Project	IEEE 802.16 Broadband Wireless Access Working Group < http://ieee802.org/16 >		
Title	Enhancements/Corrections for AAS in OFDMA PHY		
Date Submitted	2004-08-27		
Source(s)	Tal Kaitz, Ran Yaniv	Alvarion	tal.kaitz@alvarion.com , ran.yaniv@alvarion.com
	Adam Kerr, Paul Petrus,	ArrayComm Inc.	adam@arraycomm.com , petrus@arraycomm.com
	Uri Perlmutter, Hassan Yaghoobi	Intel Corp	uri.perlmutter@intel.com , hassan.yaghoobi@intel.com
Re:	IEEE P802.16-REVe/D4		
Abstract	This contribution introduces enhancements/corrections for support of AAS in the OFDMA PHY.		
Purpose	Adopt into P802.16e/D4.		
Notice	This document has been prepared to assist IEEE 802.16. It is offered as a basis for discussion and is not binding on the contributing individual(s) or organization(s). The material in this document is subject to change in form and content after further study. The contributor(s) reserve(s) the right to add, amend or withdraw material contained herein.

Enhancements/Corrections for AAS in OFDMA PHY

8.4.4.6.1 AAS frame structure

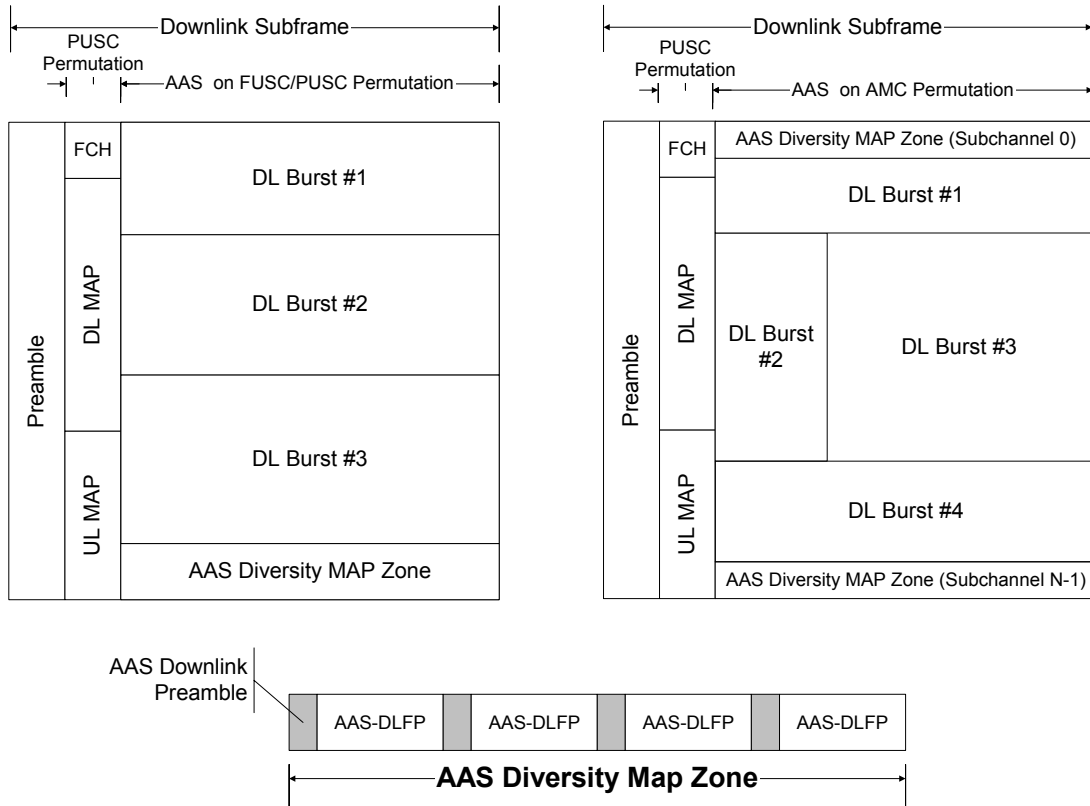
The AAS DL Zone begins on a symbol boundary and consists of all subchannels until the beginning of the UL subframe for TDD or until the end of the frame for FDD. ~~The two highest numbered subchannels of the AAS DL Zone frame may be dedicated at the discretion of~~ are dedicated by the BS for the AAS Diversity-Map Zone in the PUSC, FUSC and optional FUSC permutation. For the PUSC permutation, it is assumed that all AAS subscribers can decode the FCH in order to know the Used Subchannel Bitmap. In the AMC permutation, ~~the 4th and (N-4)th first and last subchannels of the total N subchannels of the AAS DL Zone frame may be dedicated at the discretion of~~ are dedicated by the BS for the AAS Diversity-Map Zone. For AMC permutation, each subchannel for the AAS diversity MAP consists of 3 bins by 2 symbols. When these subchannels are used for this purpose, they shall not be otherwise allocated in ~~the normal DL-MAP messages, and shall be used only on the AAS portion of the DL sub-frame.~~ These sub-channels will be used to transmit the AAS-DLFP() whose physical construction is shown in Figure 223.

[Replace figure 224 with the following]
